## Removal of Inner 5/8" Type X Drywall Requirement

Figure 1: Framing Installation without Inner 5/8" Type X Drywall Layer

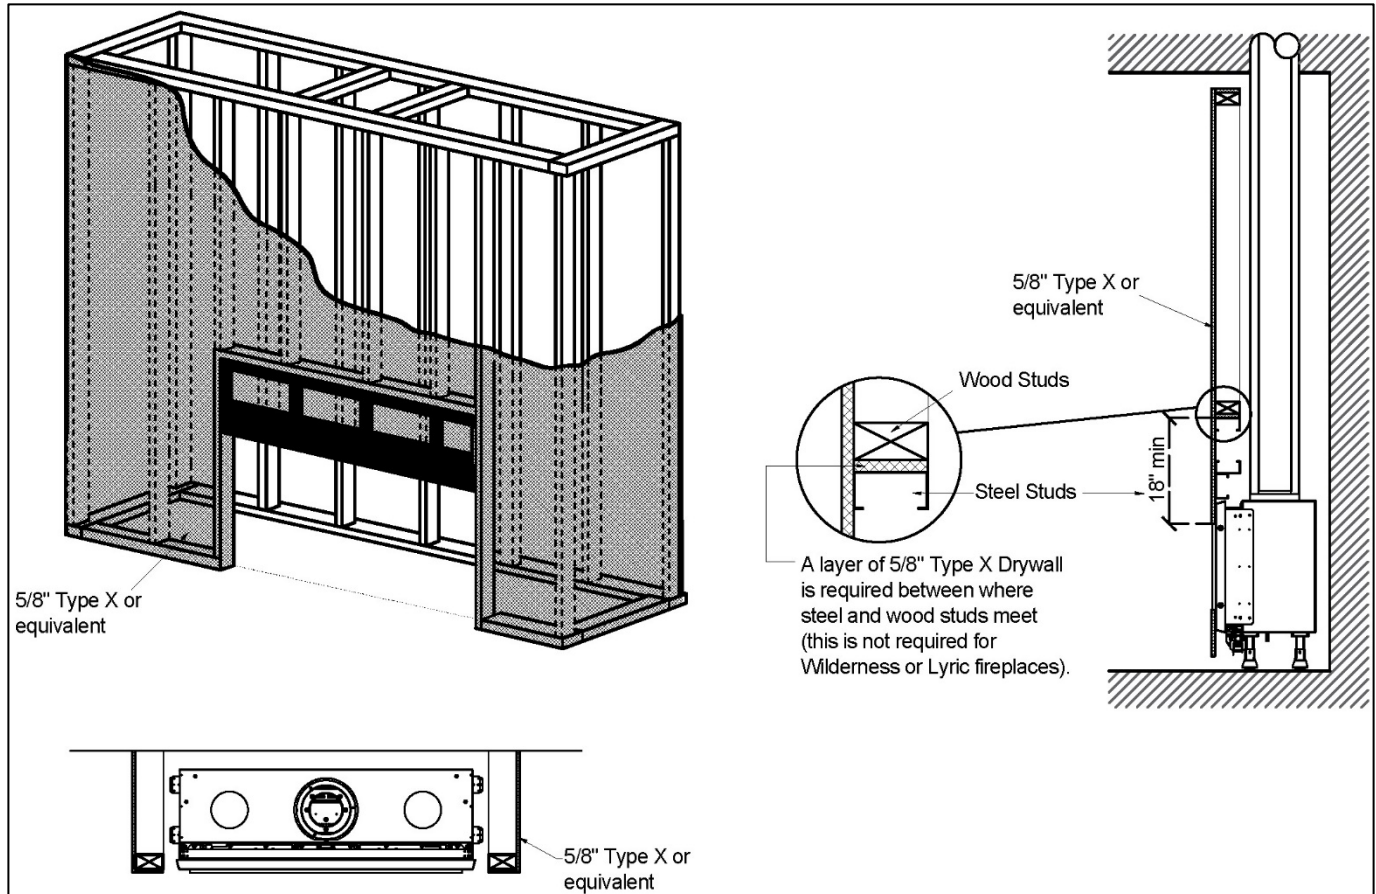
We are happy to announce that Ortal, Lyric, and Wilderness fireplaces are approved to be installed without an inner layer of 5/8" Type X Drywall inside the chase. This approval applies to all Ortal-manufactured built-in fireplaces sold in the North American market, with exception of the Ortal Traditional 90 & 110.

The temperatures inside the cavity can reach up to 90°F above room temperature and the appliances are meeting these criteria and approved by CSA with no requirement to use the inner layer of 5/8" Type X Drywall.

Figure 1 below illustrates framing installation without the inner layer of 5/8" Type X Drywall inside the chase.
